DATE: March 11th, 2026

RE: Addendum No. 1 to the Bidding Documents for:
NPS Gateway National Park Maintenance Building
Schemmer Project No. 009258.012

This addendum consists of two (2) pages of written addendum items and twelve (12) pages of supplemental drawings.

ARCH/ENG PROJ # 09258.012
SUB SHEET NO. **M001**
DRAWING NO. 366 / 80034
PMIS / PKG. NO. **320855**
SHEET **4** OF **16**

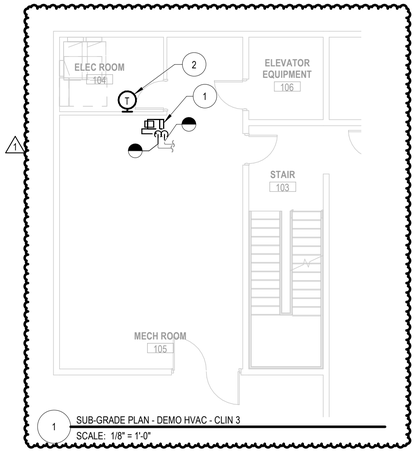
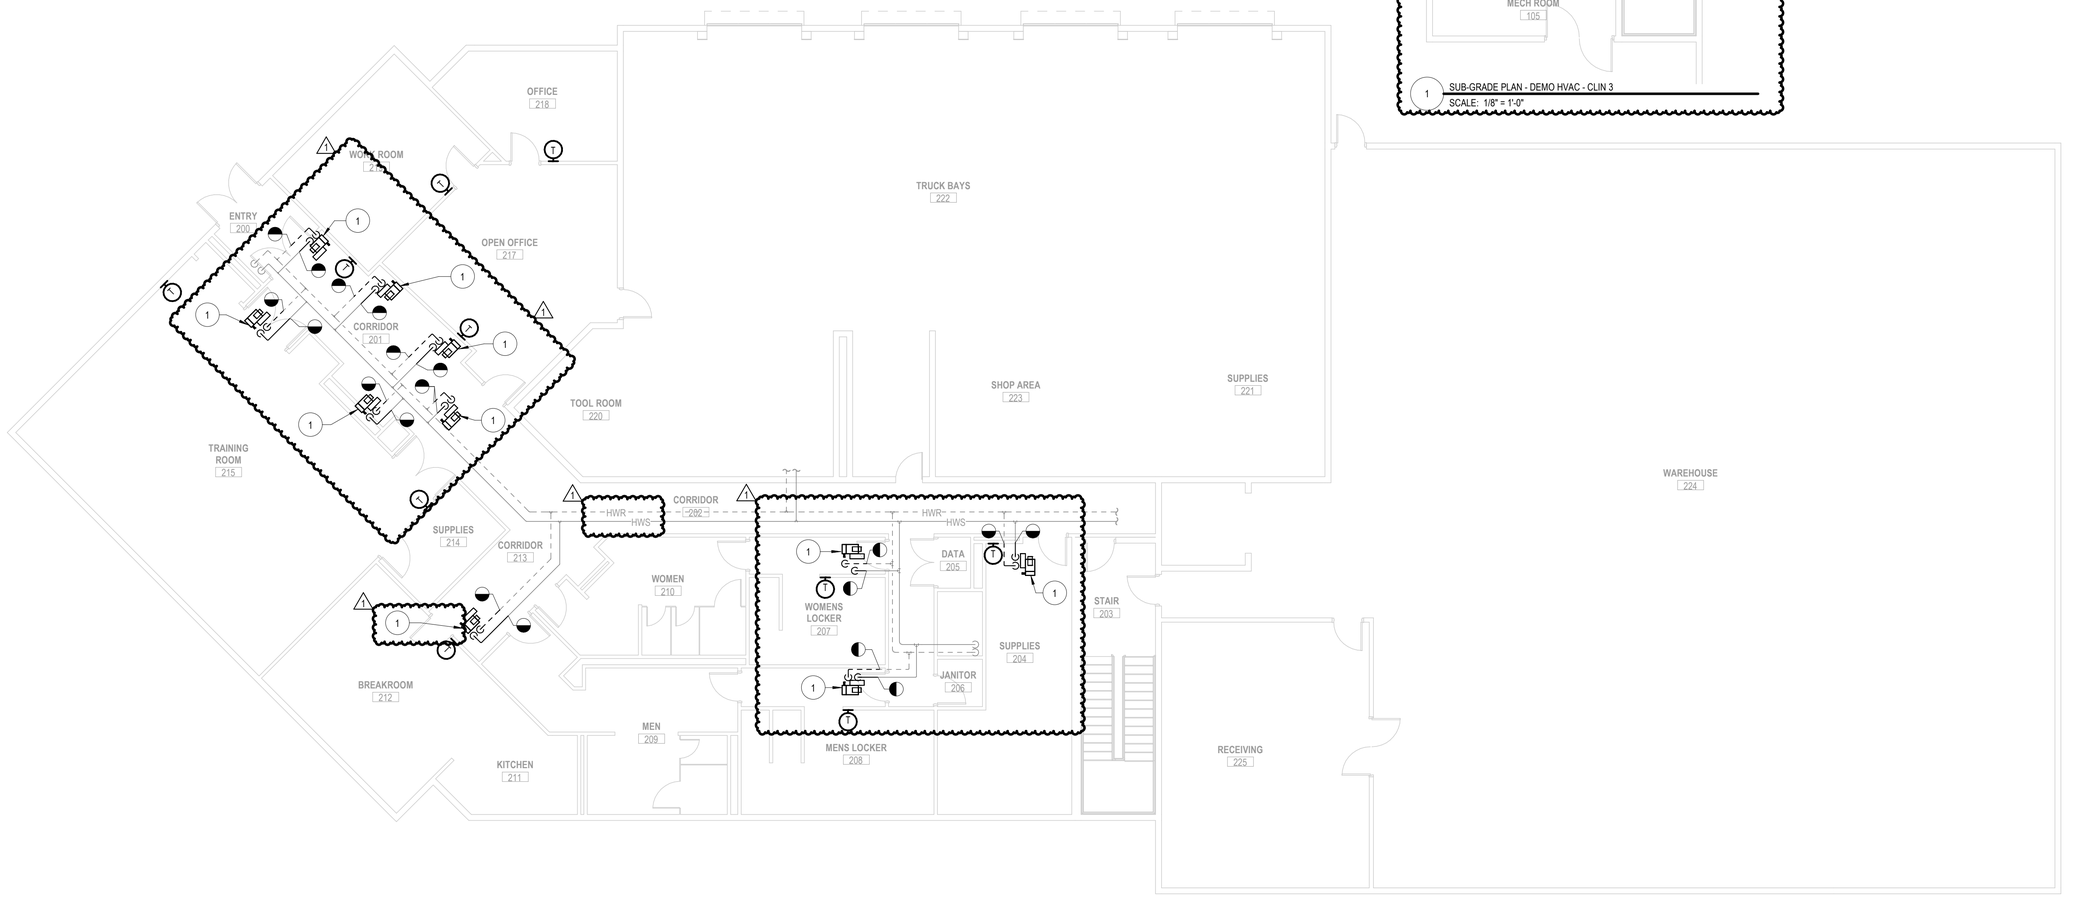
Item No. DM-1, Sheet M001
Changed view title to include the Contract Line Item Number (CLIN) associated with the work depicted in the view. Modified keynotes, added view showing VAV-11 scope, removed tags from equipment being removed.

1 REMOVE EXISTING VAV BOX AND ASSOCIATED PIPING SPECIALTIES. PROTECT CONNECTED DUCTWORK FOR RECONNECTION TO NEW VAV BOX. SEE M101 FOR ADDITIONAL INFORMATION. REMOVE ASSOCIATED THERMOSTAT. PROVIDE BLANK OFF PLATE OVER EXISTING THERMOSTAT OPENING IF REQUIRED FOR NEW THERMOSTAT.

2 CONTRACTOR TO FIELD VERIFY VAV-11 THERMOSTAT LOCATION.

ARCH/ENG PROJ # 09258.012
SUB SHEET NO. **M002**
DRAWING NO. 366 / 80034
PMIS / PKG. NO. **320855**
SHEET **5** OF **16**

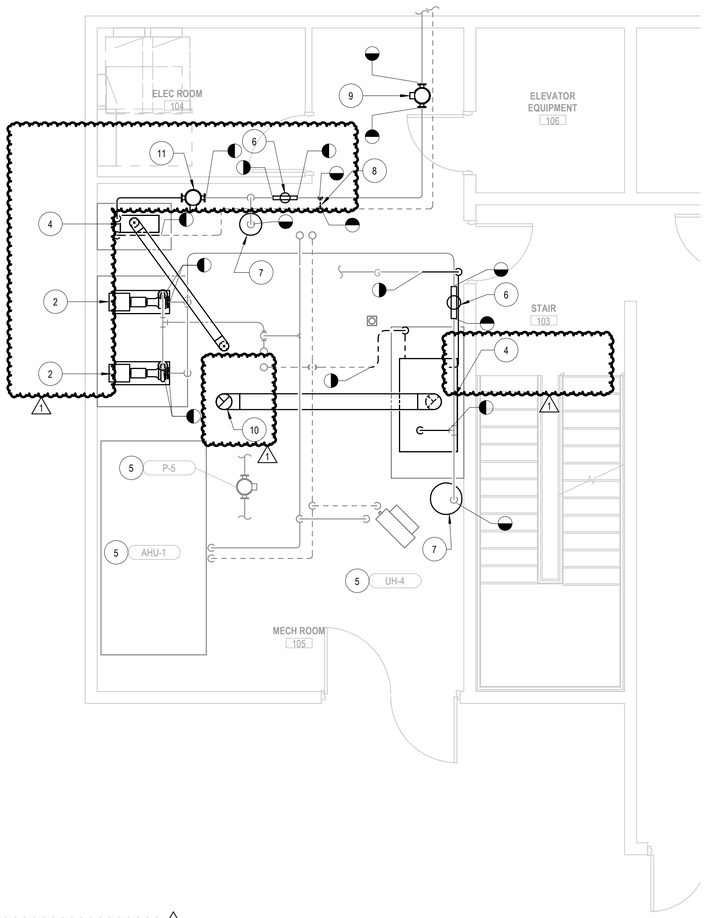
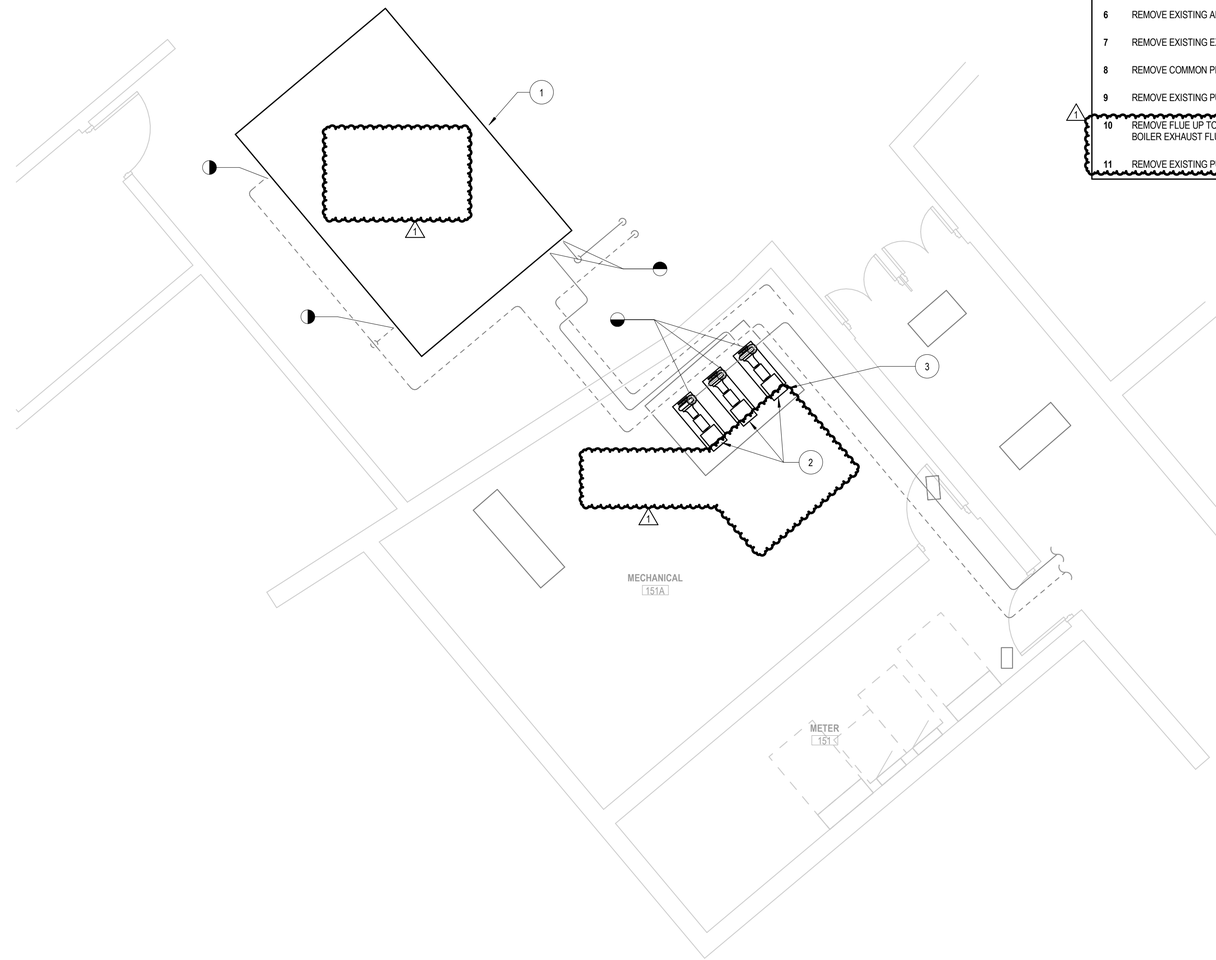
Item No. DM-2, Sheet M002
Changed view title to include the Contract Line Item Number (CLIN) associated with the work depicted in the view. Modified keynotes, modified demo to existing tags, removed tags from equipment being removed.

ARCH/ENG PROJ # 09258.012
SUB SHEET NO. **M101**
DRAWING NO. 366 / 80034
PMIS / PKG. NO. **320855**
SHEET **6** OF **16**

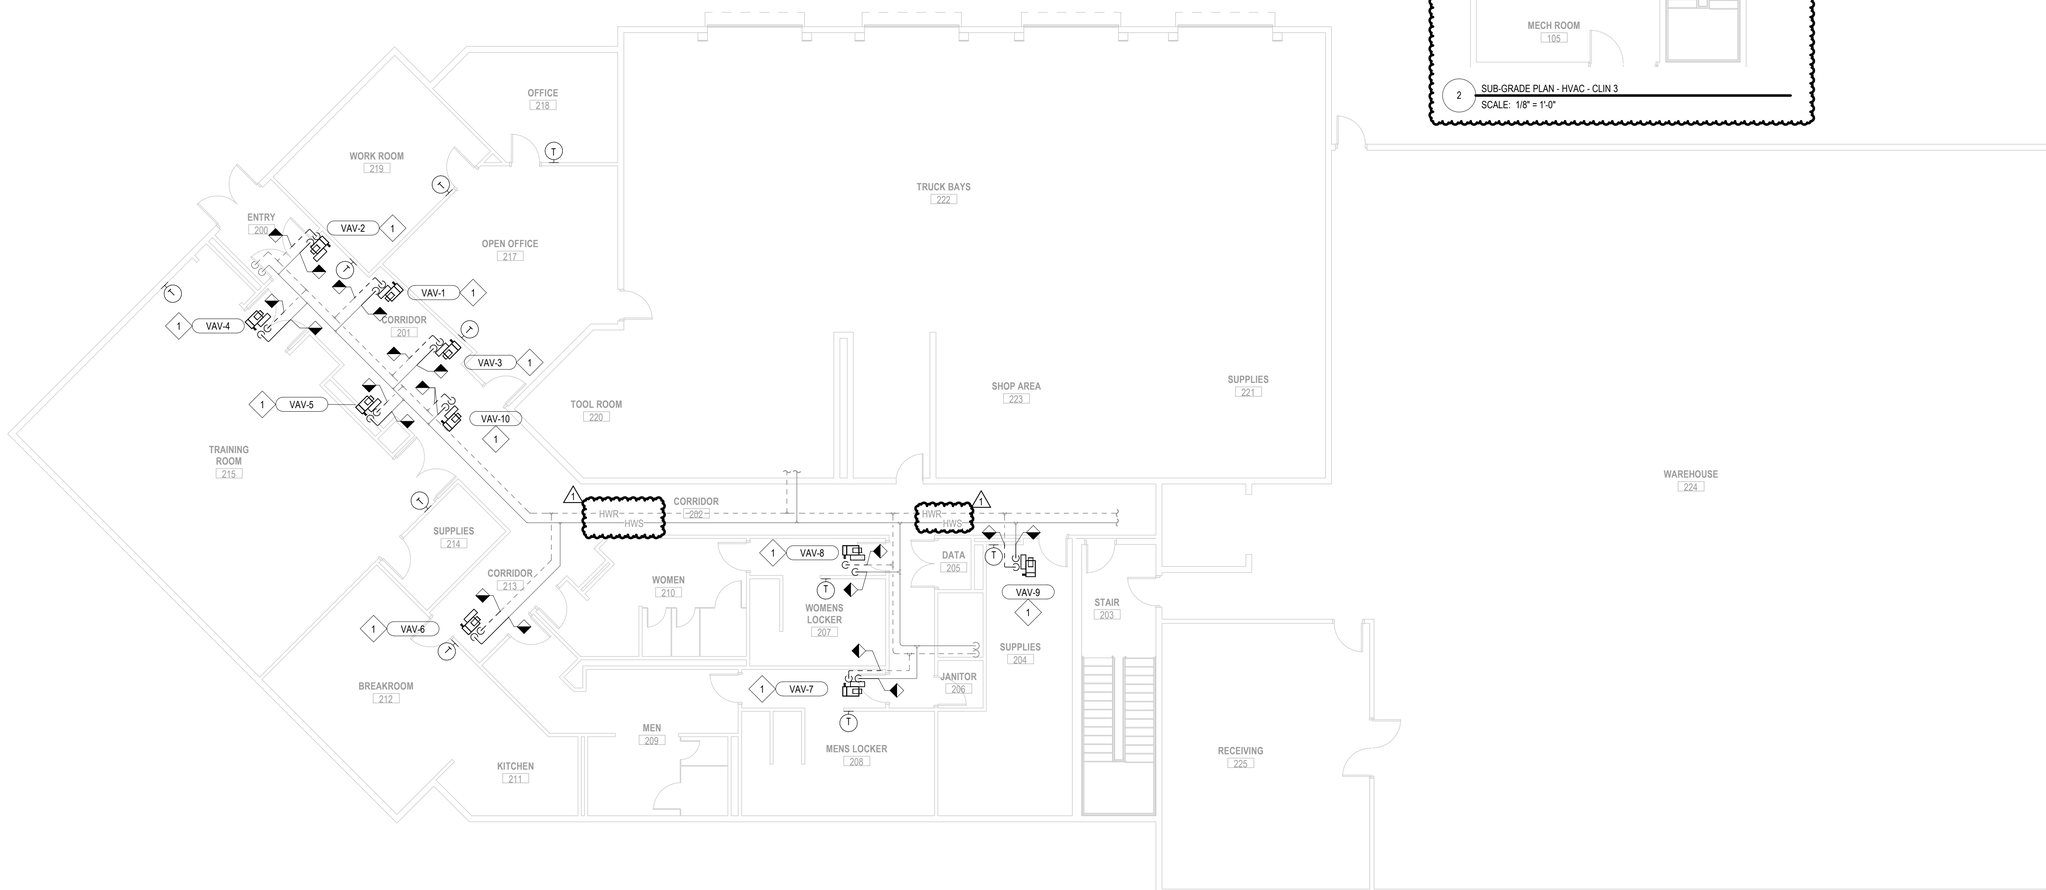
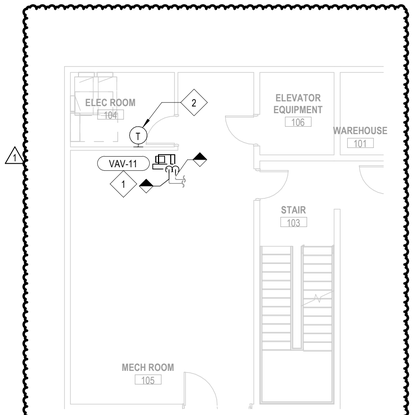
Item No. DM-3, Sheet M101
Changed view title to include the Contract Line Item Number (CLIN) associated with the work depicted in the view. Modified keynotes, added view showing VAV-11 scope,

1 REPLACE VAV BOX AS SHOWN. PROVIDE NEW PIPING SPECIALTIES AND CONNECT TO EXISTING PIPING AND DUCTWORK. PIPING CONNECTIONS FOR EVERY VAV BOX IS TO BE 3/4". INSTALL NEW THERMOSTAT IN PREVIOUS THERMOSTAT LOCATION. PROVIDE BLANK OFF PLATE OVER EXISTING THERMOSTAT OPENING IF REQUIRED FOR NEW THERMOSTAT.

2 CONTRACTOR TO FIELD VERIFY VAV-11 THERMOSTAT LOCATION.

ARCH/ENG PROJ # 09258.012
SUB SHEET NO. **M102**
DRAWING NO. 366 / 80034
PMIS / PKG. NO. **320855**
SHEET **7** OF **16**

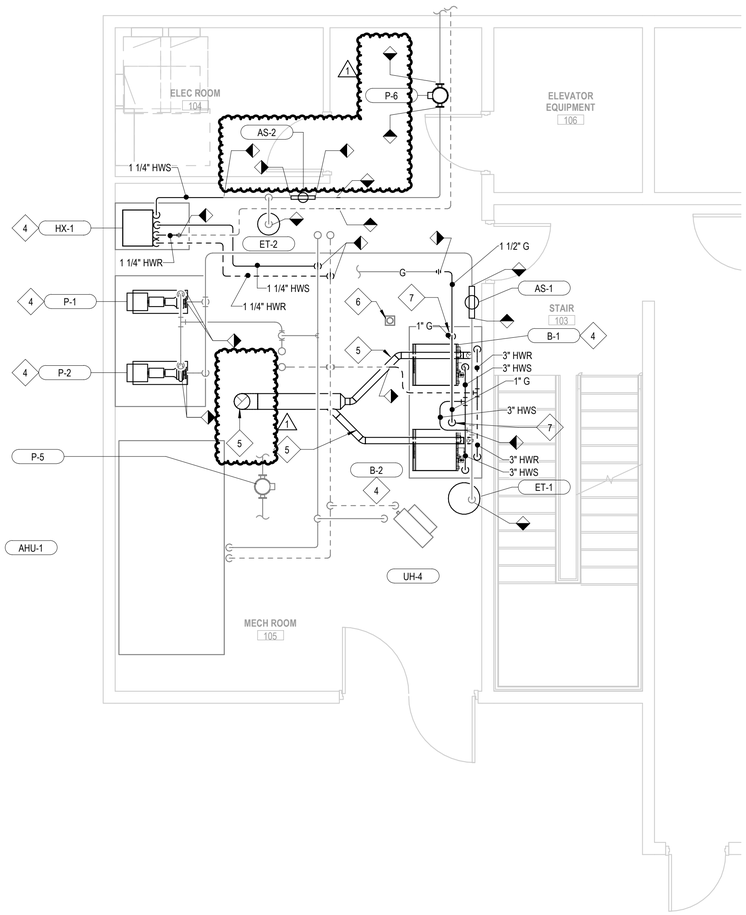
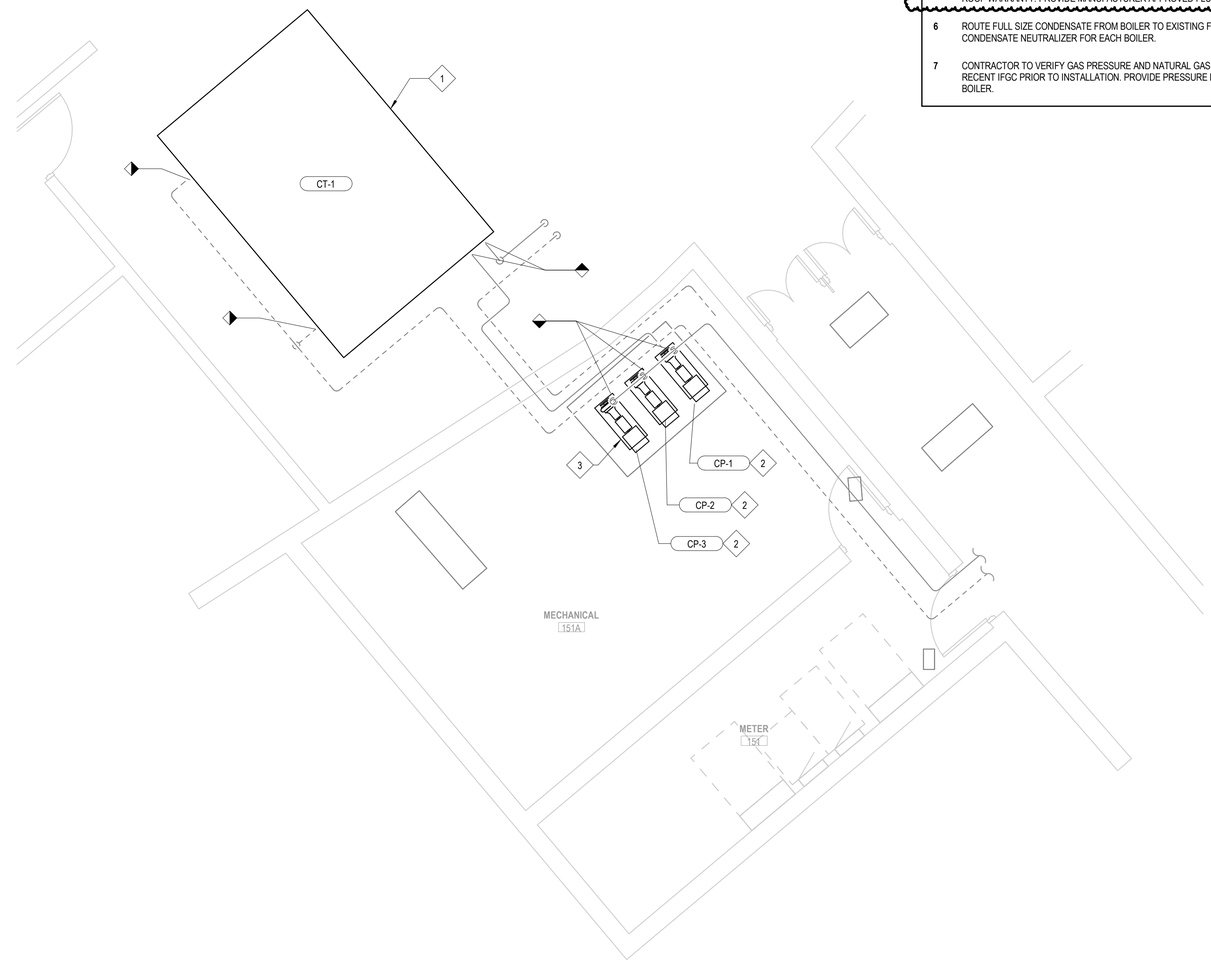
Item No. DM-4, Sheet M102
Changed view title to include the Contract Line Item Number (CLIN) associated with the work depicted in the view. Modified keynotes and new to existing symbols.

8 GAS FLUE THRU ROOF DETAIL
SCALE: NOT TO SCALE

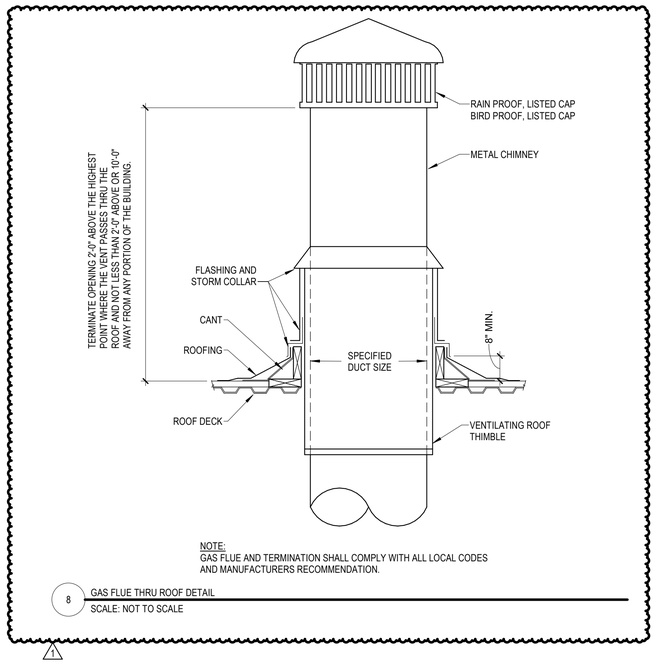
Item No. DM-5, Sheet M401
Added detail for gas flue through roof.

NOTE:
GAS FLUE AND TERMINATION SHALL COMPLY WITH ALL LOCAL CODES AND MANUFACTURERS RECOMMENDATION.

ARCH/ENG PROJ # 09258.012
SUB SHEET NO. **E001**
DRAWING NO. 366 / 80034
PMIS / PKG. NO. **320855**
SHEET **12** OF **16**

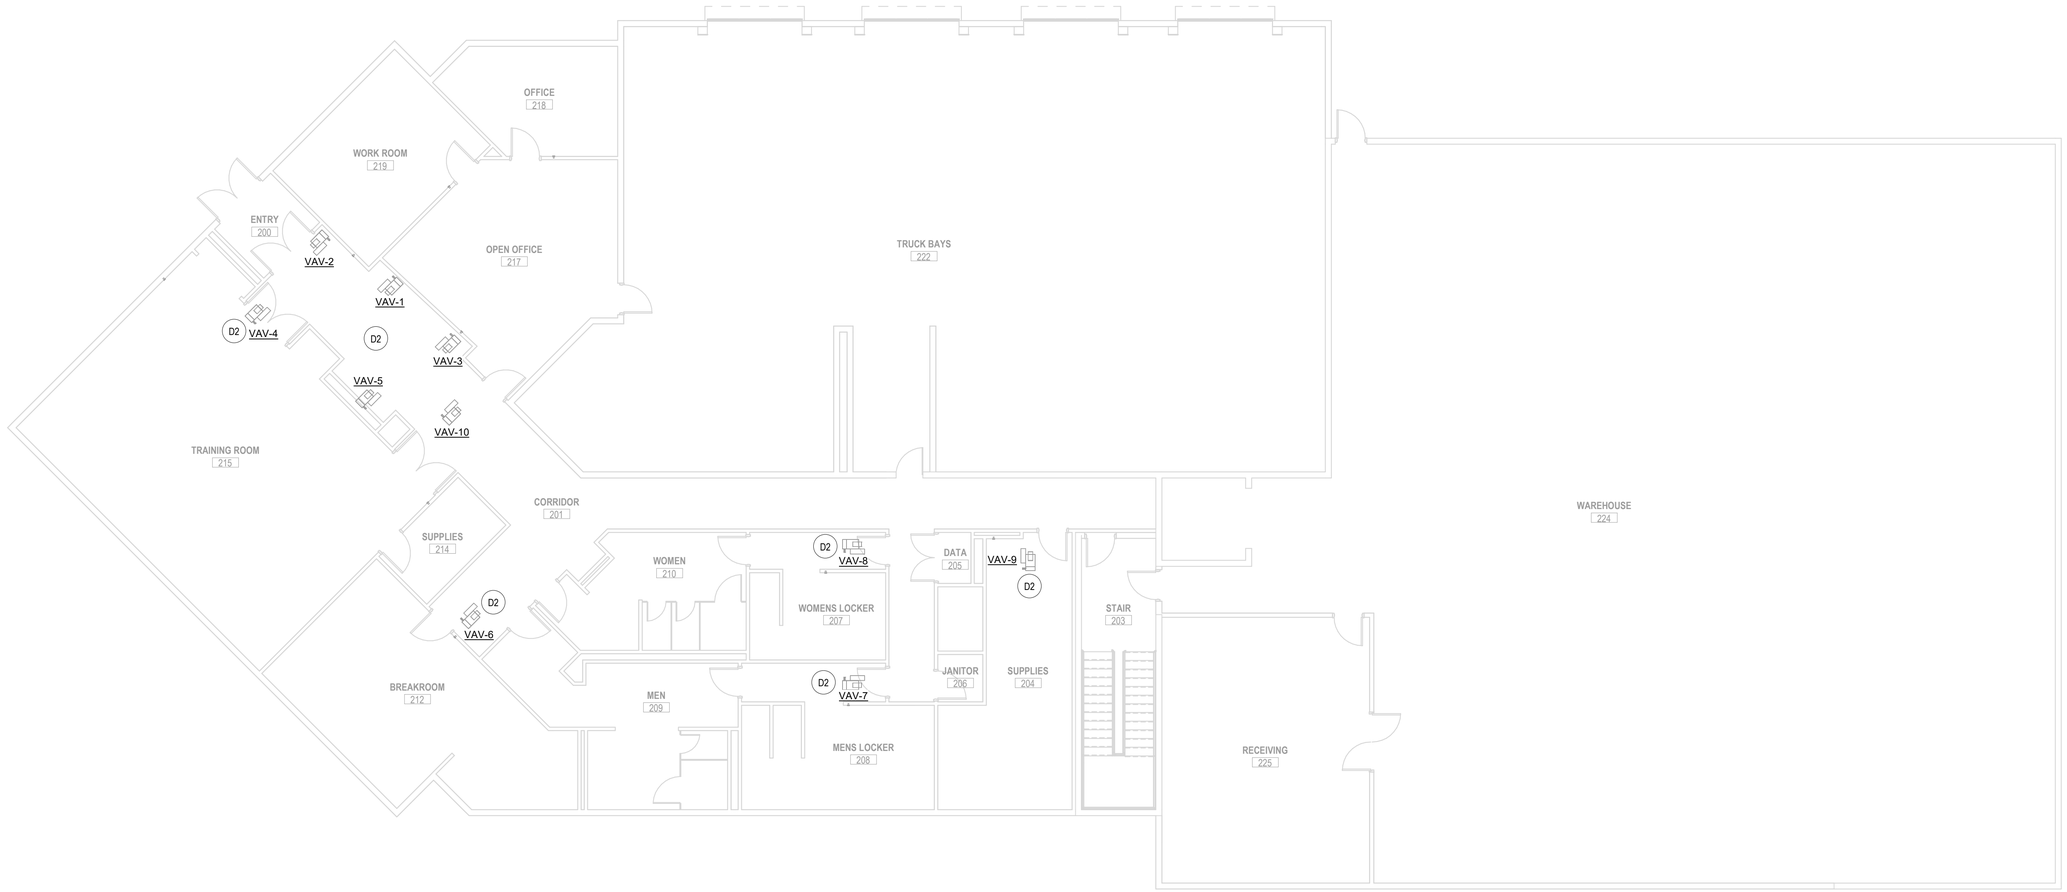
Item No. DE-2, Sheet E001
Changed view title to include the Contract Line Item Number (CLIN) associated with the work depicted in the view.
